From: [Brissette, Renee C.](#)
To: ["Glenn Broughton"](#)
Cc: [Gomez, Ernest P.](#); [Blount, Veronica](#)
Subject: Kasemn Total Joint Replacement Center - J19D004F
Date: Monday, December 28, 2020 8:16:59 AM

Kaseman Hospital Total Joint Replacement Center: BP

PKH TOTAL JOINT CENTER
SITE DEVELOPMENT PLAN FOR BUILDING PERMIT
8300 CONSTITUTION AVE. SE
ALBUQUERQUE, NM 87110

EXISTING &
PROPOSED
DRAINAGE
MANAGEMENT PLAN

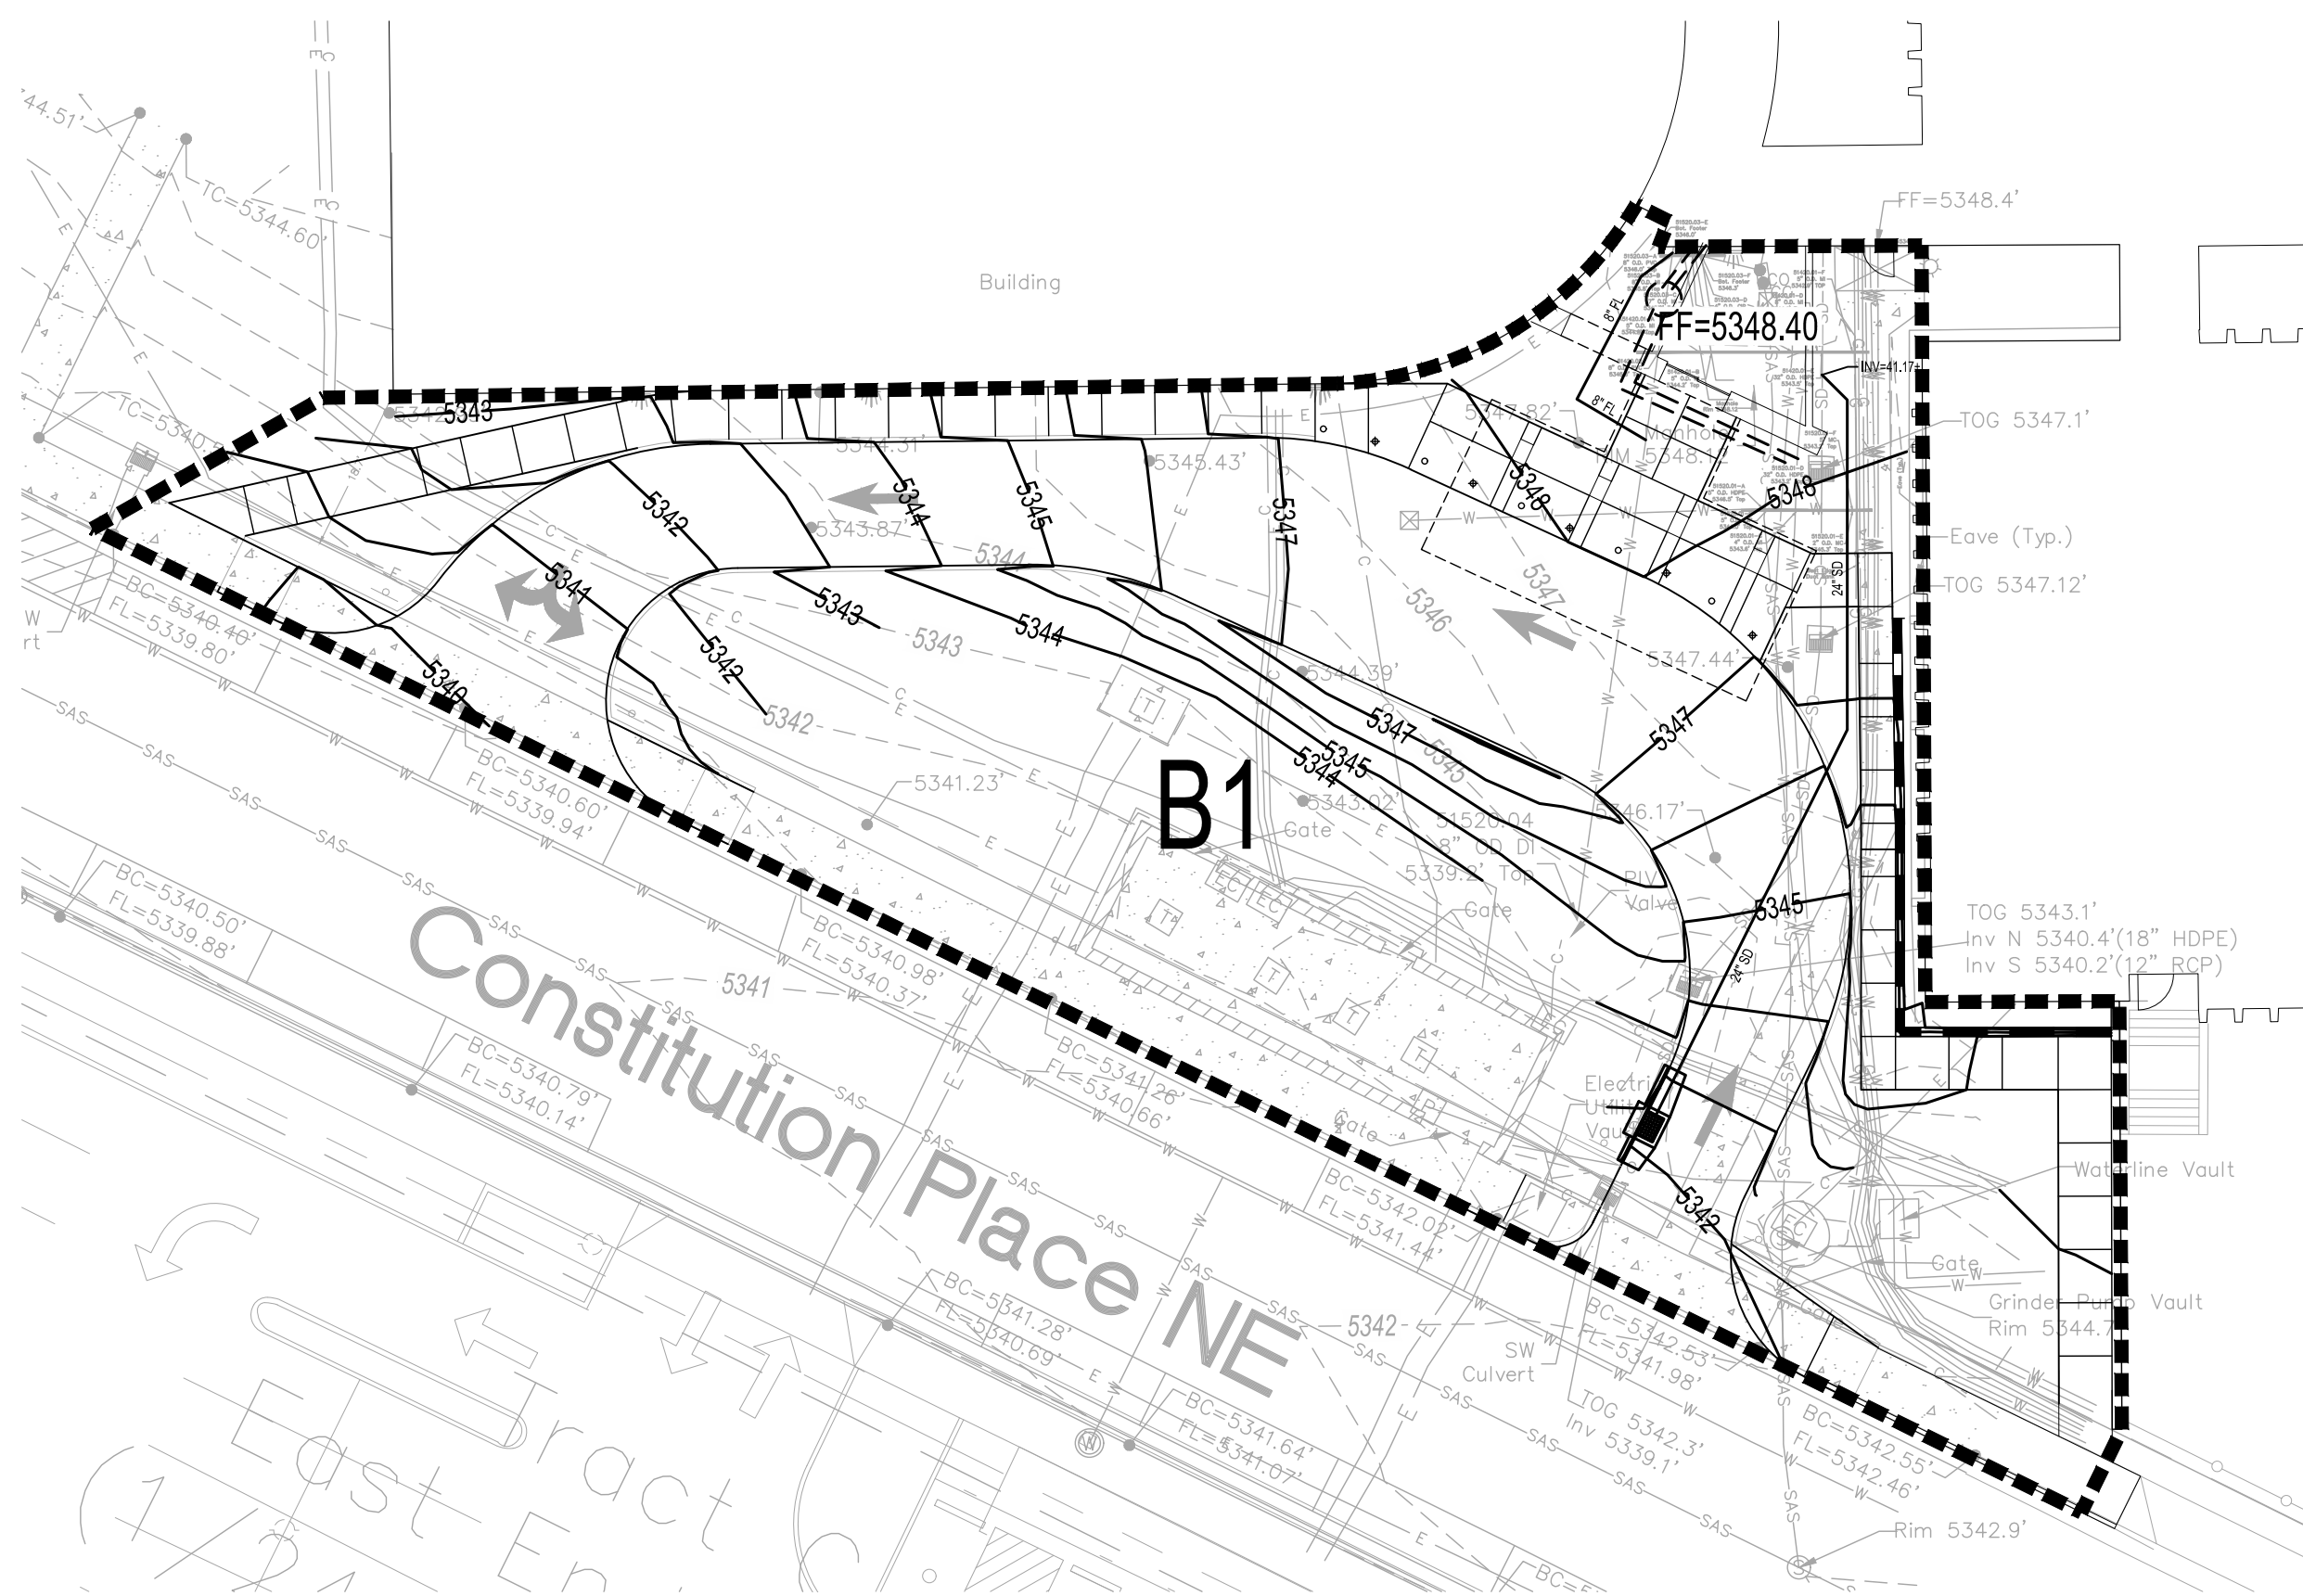
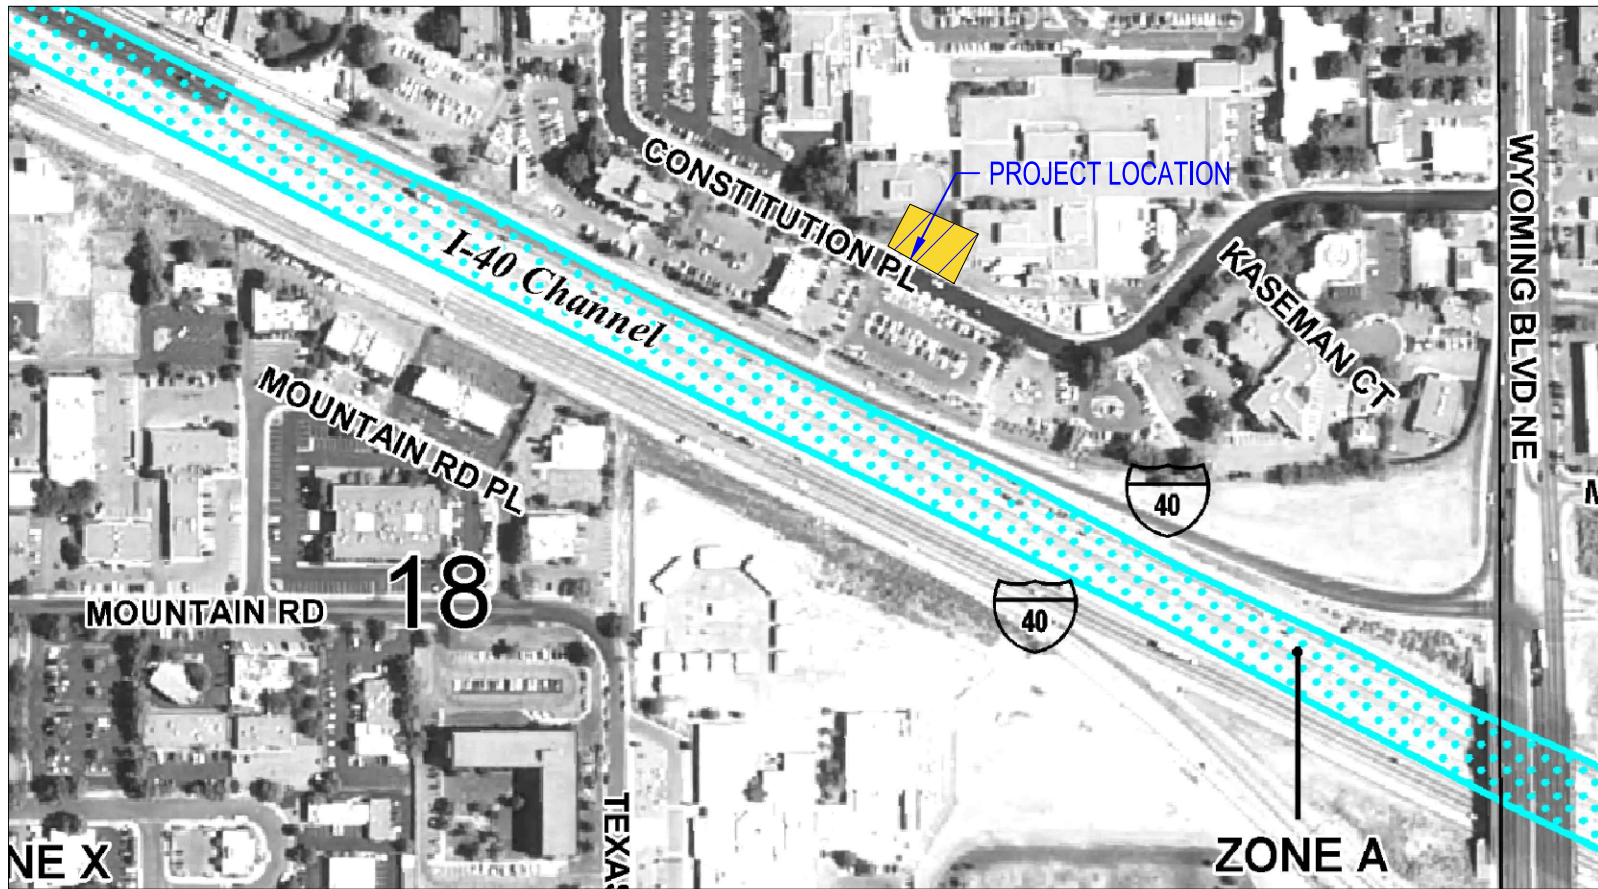
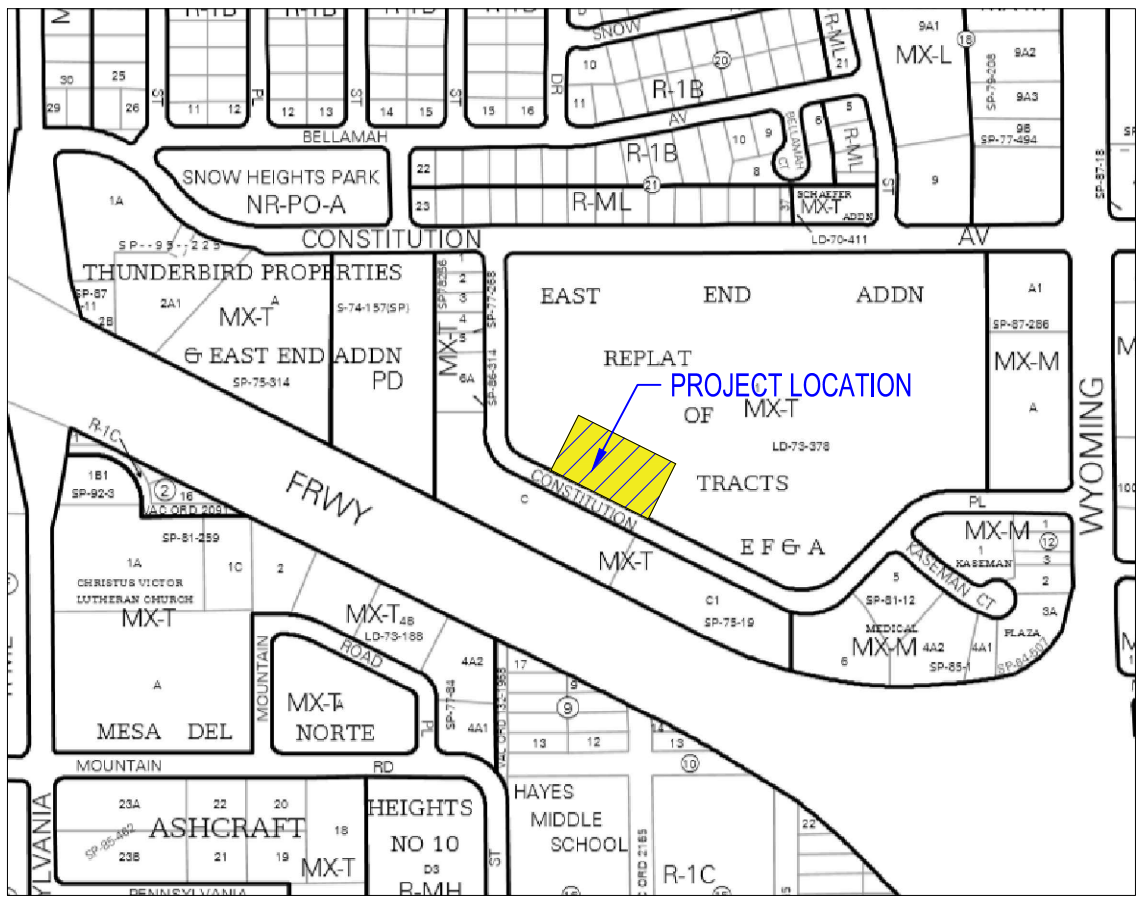
I know that you told me to keep this open, but it has been almost four months without any activity. I need to close this project out from our queue. This email will serve as a denial for the project. Please note that the only thing that is needed to approve this project is the Payment-in-Lieu for the stormwater quality pond volume in the amount of \$1,568.00. Once this is paid, then please just resubmit with an admin fee of \$40 and Hydrology will issue an approved stamped G&D and an approval letter for this project.
